OUR LADY OF GETHSEMANI
TRAPPIST, KENTUCKY

Feb 5, 1960

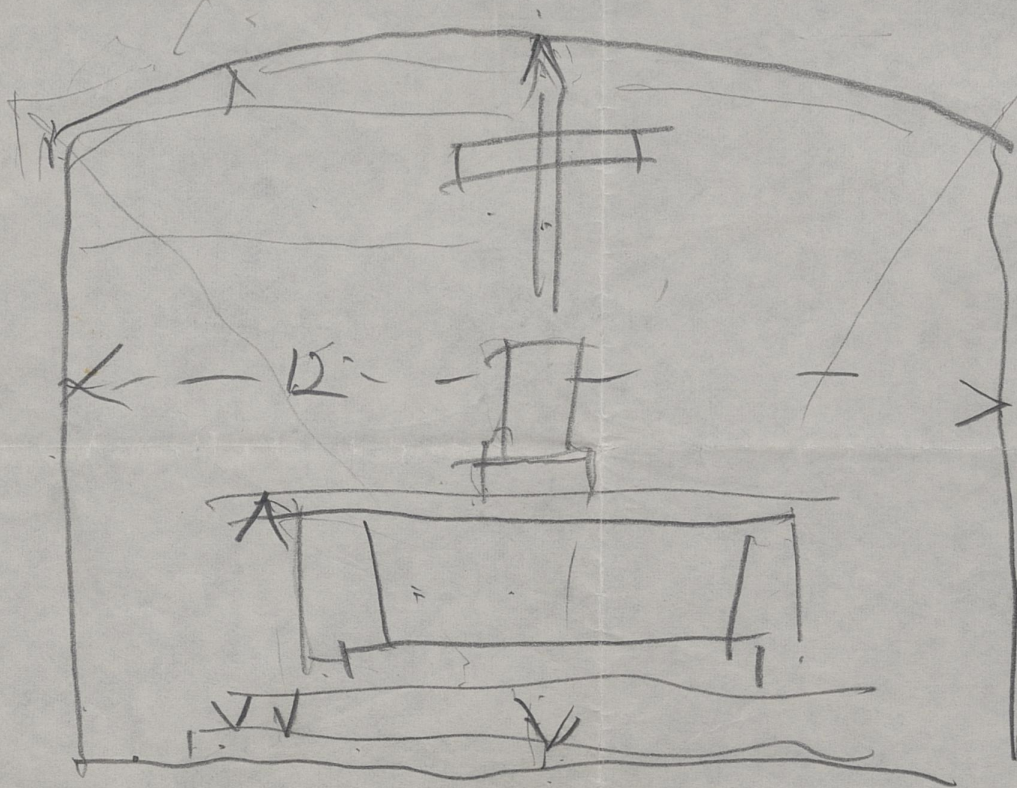
About the tabernacle: do not think that I am clinging madly to some idea of my own about how it ought to be. I leave entirely to you the external form and design of the tabernacle. The only thing that I have to be concerned about is that the tabernacle should conform to the canonical regulations. These are in brief:

- 1) That it should be in the middle of the altar (half way between ends)
- 2) That it be fixed to the altar or in some way un-movable.
- 3) It should be, interiorly, very solid and safe-like, so that it cannot be broken into, as far as possible. It cannot in other words be a plain wooden box. The outside casing can be wood. As for the inside "safe" you can go about that any way you like or even get someone else to make it I do not know how to explain it in such a way that it will not deter you from the project. It just has to be very solid and secure. You can fill this prescription in any way you like as long as it is taken care of.

- 4) Inside, the dimensions should be such as to permit putting away a ciborium over 18 inches high. Or at least 19 inches. And there are some special ways of making the inside formal and lavish with silk or something, which I think is probably non essential, and if it isn't maybe some brother can take care of that here.
